AGENDA
MANOR PLANNING AND ZONING COMMISSION
105 E. EGGLESTON ST.
MANOR, TEXAS 78653
MARCH 9, 2016 6:30 P.M.

Re: First Construction Plan and Final Plat Review for
Shadowglen Phase 2, Section 20 Subdivision
City of Manor, Texas

Re: Stonewater North Subdivision
Fourth Preliminary Plan Application Submittal
City of Manor

Re: First Short Form Final Plat Review for
Whataburger
City of Manor, Texas

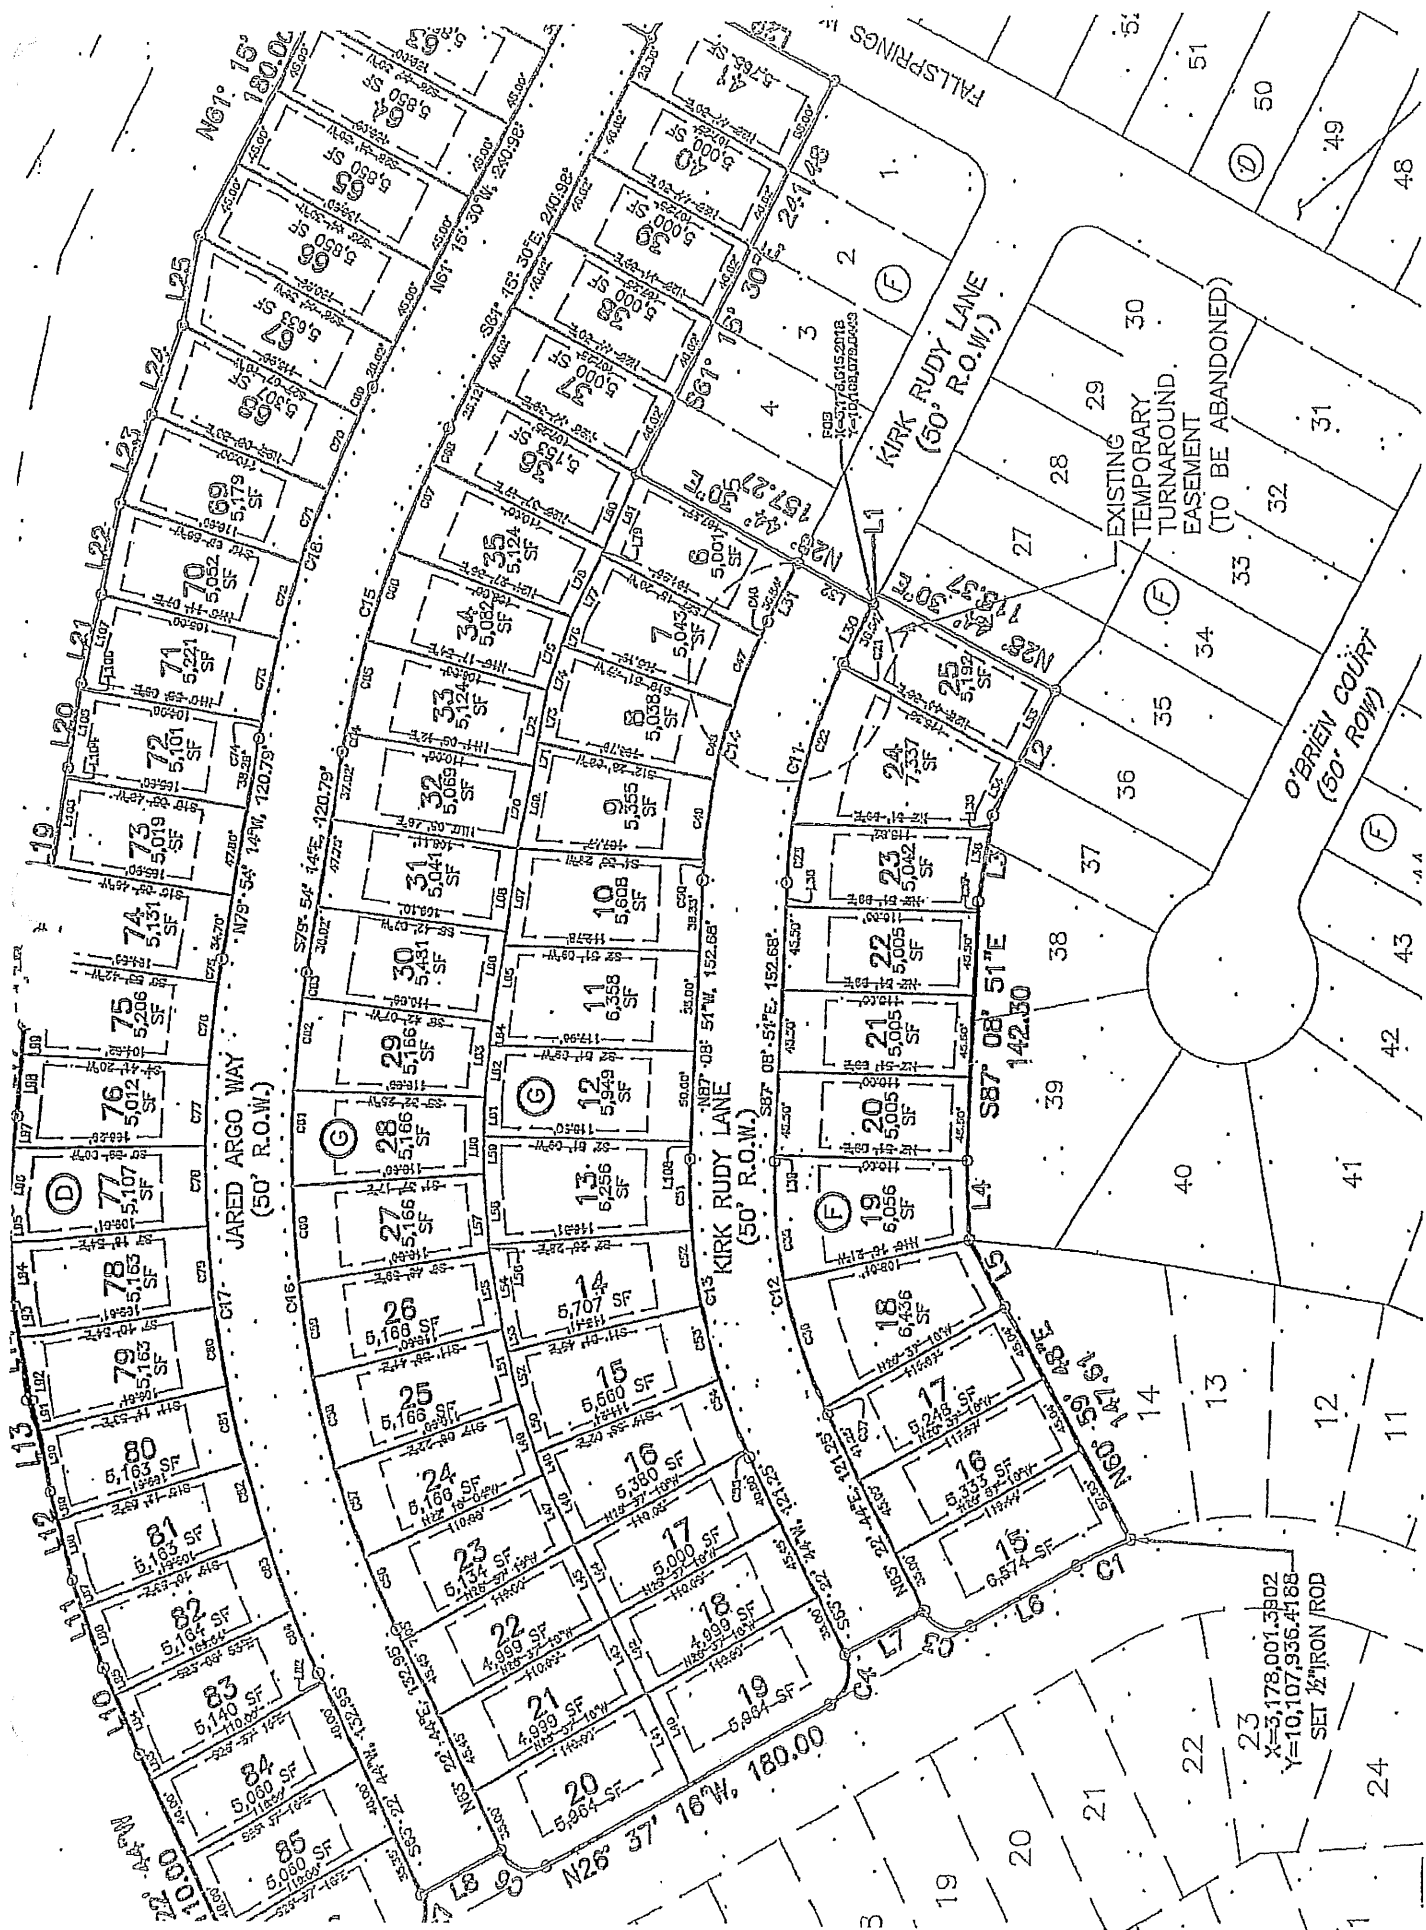
1. Provide Geotechnical Engineering Report and Pavement Design for all proposed streets and include a table or detail of proposed pavement section for each street.
2. FYI - the AARV detail should be updated to utilize the City of Manor modification or City of Austin Standard that utilizes PE pipe rather than copper tubing.
3. Include the final plat in the plans.
4. Provide benchmarks on plat and/or plans.
5. The submitted tax certificates show taxes paid for 2013 and Delinquent taxes from prior years. Tax certificates must be submitted showing all taxes paid as required in Section 24(d)(2)(v) of Subdivision Ordinance 159.

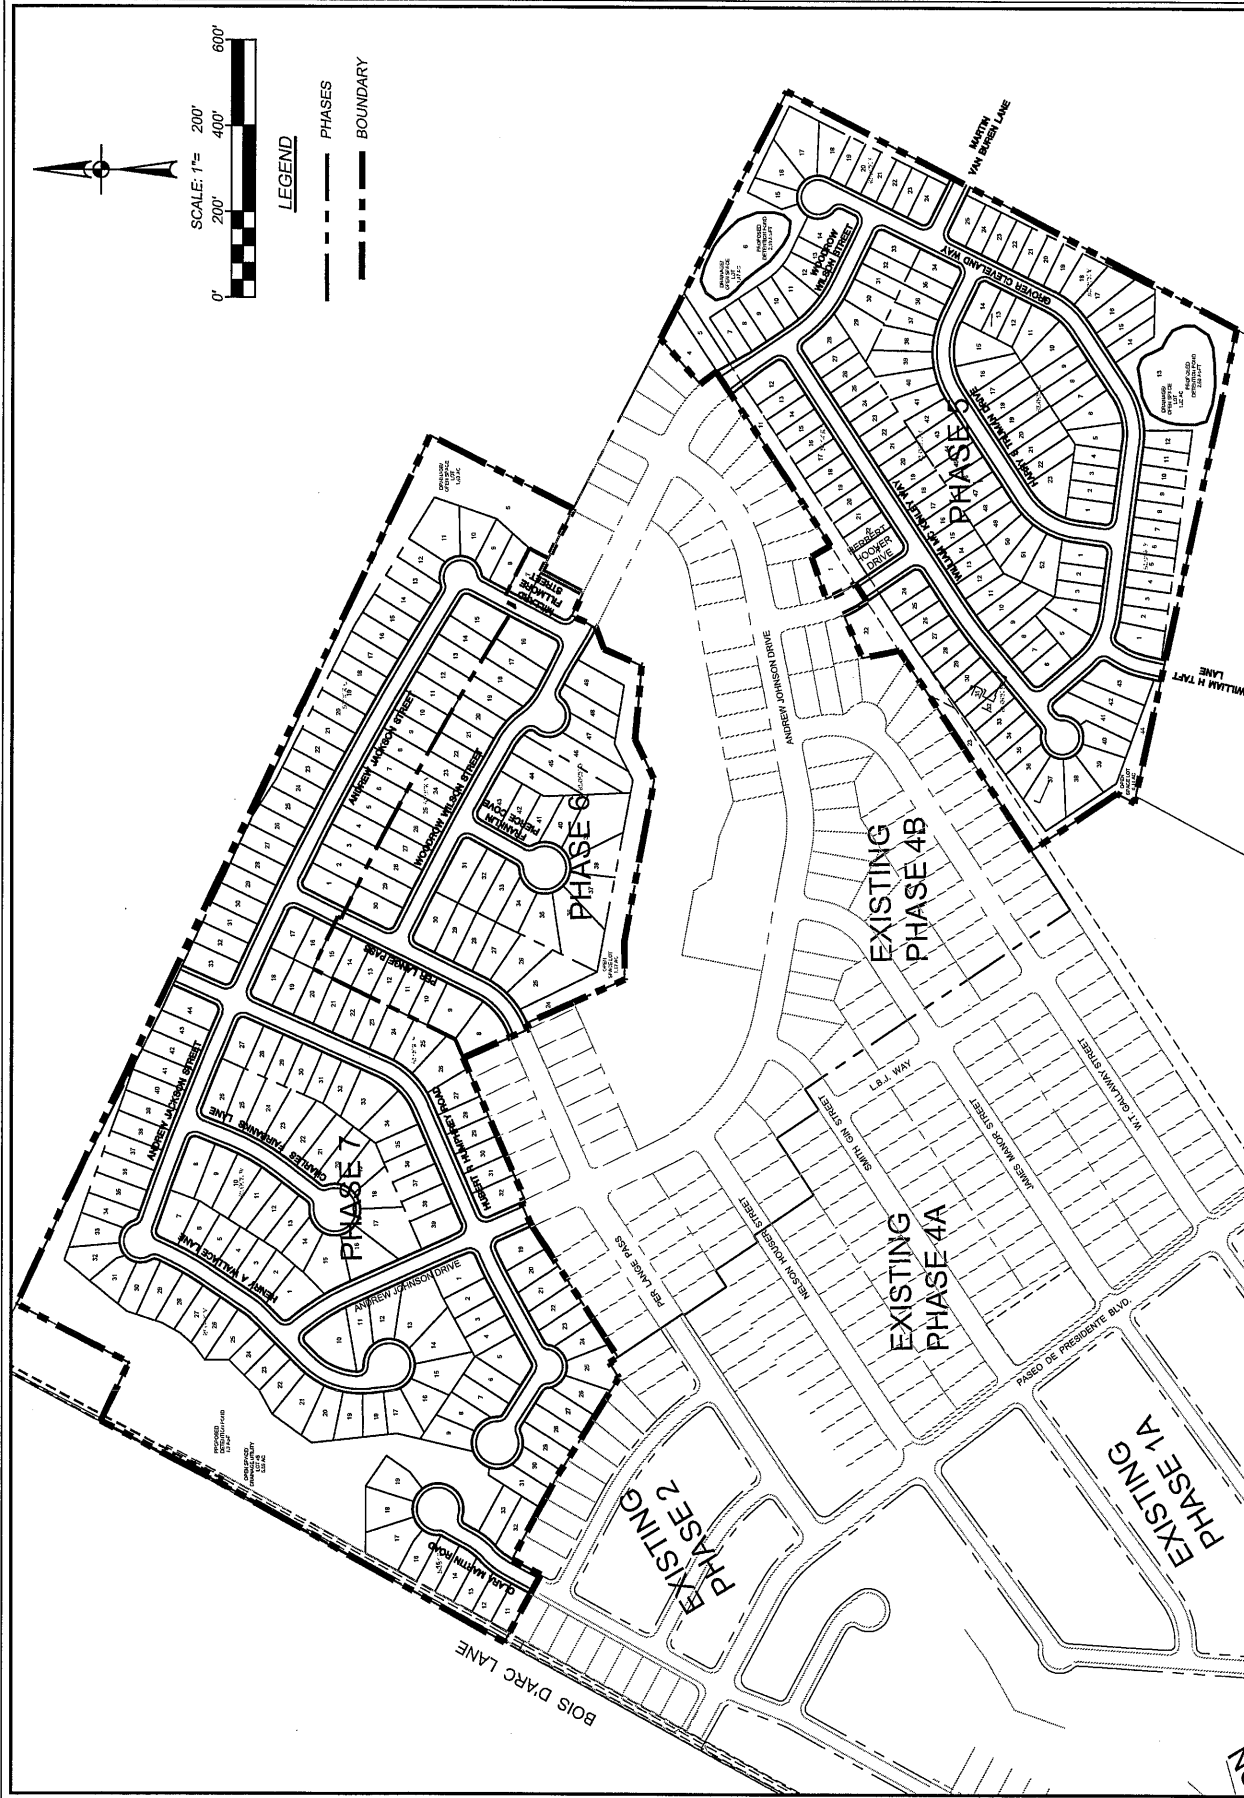
1. The acreage listed in the project summary memo does not match the acreage on the cover.
2. There is a note in regards to FEMA that is cut off on the existing conditions sheets.
3. Acreages should be shown for all open space lots.
4. No utility demand data was submitted.
5. Verify that street names not extended from other recorded plats are approved by Travis County 911 Addressing.

1. The acreage listed in the project summary memo does not match the acreage on the cover.
Project summary memo has been updated.
2. There is a note in regards to FEMA that is cut off on the existing conditions sheets.
Complete note is shown.
3. Acreages should be shown for all open space lots.
Updated
4. No utility demand data was submitted.
As per City Engineer this information is not required during the preliminary plan submittal process.
5. Verify that street names not extended from other recorded plats are approved by Travis County 911 Addressing.
Verified, see attached correspondence from Travis County 911 Addressing.
